Access Compliance Report

Public Rights-of-Way

Intersection ID: 28417	Main Street: CHASTAIN_WALK_DR	Cross Street: MORROWOOD_LN	Location: NE
ADA ID: E3B0AEA72B04	Ramp Type: Perp	Initial Pass/Fail: Fail	Overall Compliance: No
Severity Score: 12.5			
Codes/Mitigation Info/Possible Solution		Field Measurements/Component Compliance

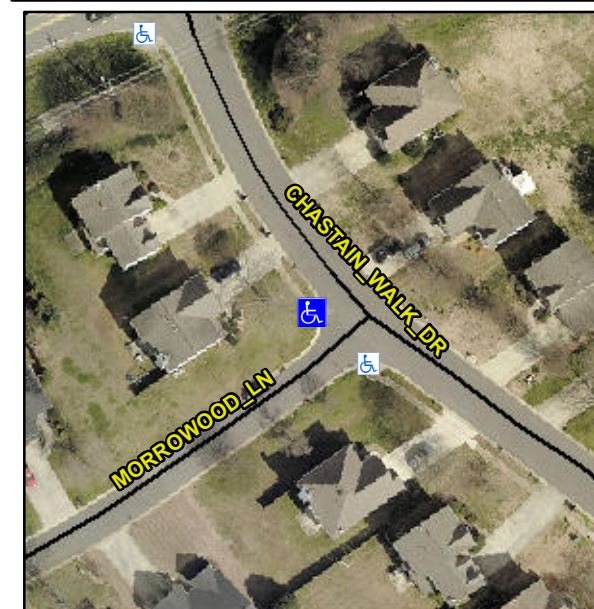
Not Found, R304.2.2

Compliance	Description	Data	Compliance	Description	Data
N/A	Ramp Length (in)	45.5	No	Ramp Slope (%)	8.5
Yes	Ramp Width (in)	48.0	Yes	Ramp XSlope (%)	0.2
N/A	Flare Type LT	N/A	N/A	Flare Type RT	N/A
N/A	Flare Slope LT (%)	N/A	N/A	Flare Slope RT (%)	N/A
N/A	Flare Traversable LT?	N/A	N/A	Flare Traversable RT?	N/A
N/A	Landing Length (in)	N/A	N/A	DWS Provided?	N/A
N/A	Landing Width (in)	N/A	N/A	DWS Contrast?	N/A
N/A	Landing Slope (%)	N/A	N/A	DWS Length (in)	N/A
N/A	Landing X Slope (%)	N/A	N/A	DWS Full Width?	N/A
N/A	Landing Curb? (Y/N)	N/A	N/A	DWS Offset (in)	N/A
N/A	Shared Landing?	N/A			
N/A	Gutter Ponding?	N/A	N/A	Gutter Slope (%)	N/A
N/A	Gutter Lip Ht (in)	N/A	N/A	Gutter X Slope (%)	N/A
N/A	Painted X Walk1?	No	N/A	Painted X Walk2?	N/A
	X Walk 1 Direction	To SE		X Walk 2 Direction	N/A
N/A	X Walk 1 Width (in)	N/A	N/A	X Walk 2 Width (in)	N/A
	X Walk 1 Slope (%)	3.2		X Walk 2 Slope (%)	N/A
	X Walk 1 X Slope (%)	2.3		X Walk 2 X Slope (%)	N/A

Remove & Replace Entire Ramp.
